APPLICATION NO:
LB/2000/1113

LOCATION:
34 Rose Street, Wokingham.

PROPOSAL:
Proposed single storey rear extension to dwelling demolition of existing rear conservatory.

Notification of Approval of Permission

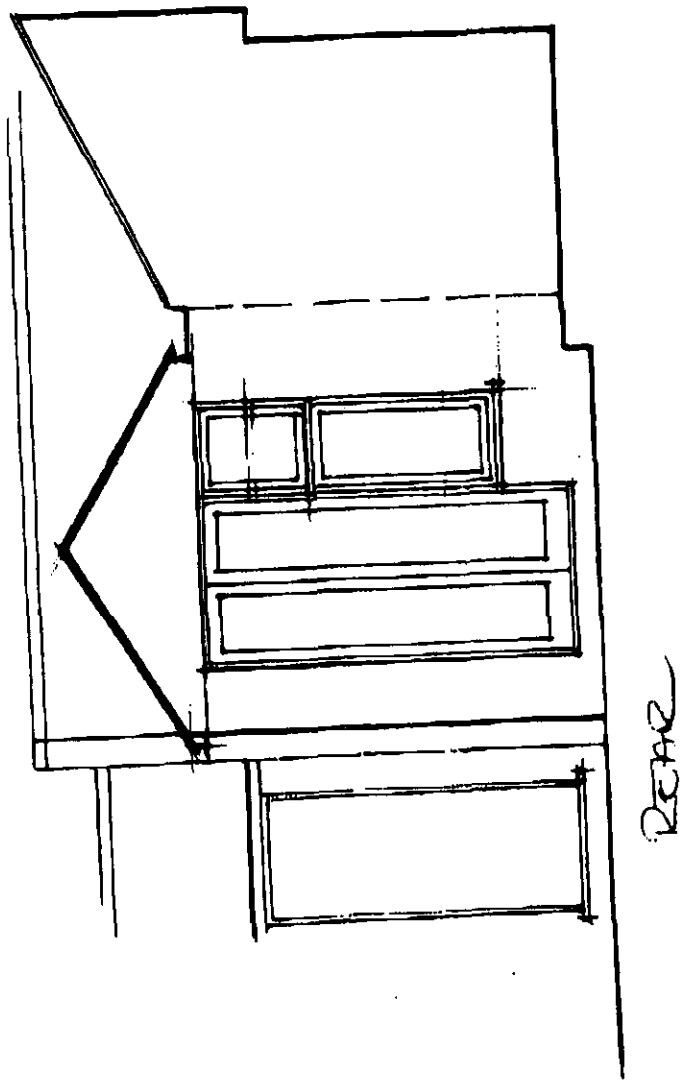
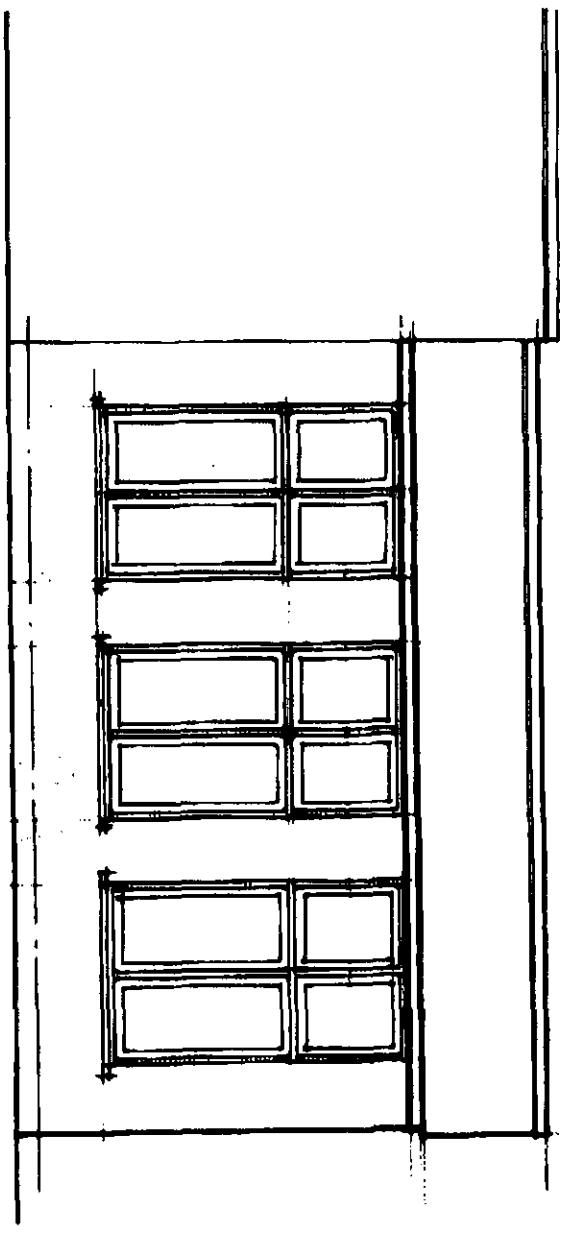
Further to our recent meeting regarding the above site, please find enclosed copies of our revised roof design for the extension. This design varies from the proposals discussed due to the roof pitches being too low for the roof tiles.

& said having spoken to Harold Sanders - ~~[illegible]~~ sketch in fax seemed OK - said they should send in [illegible]
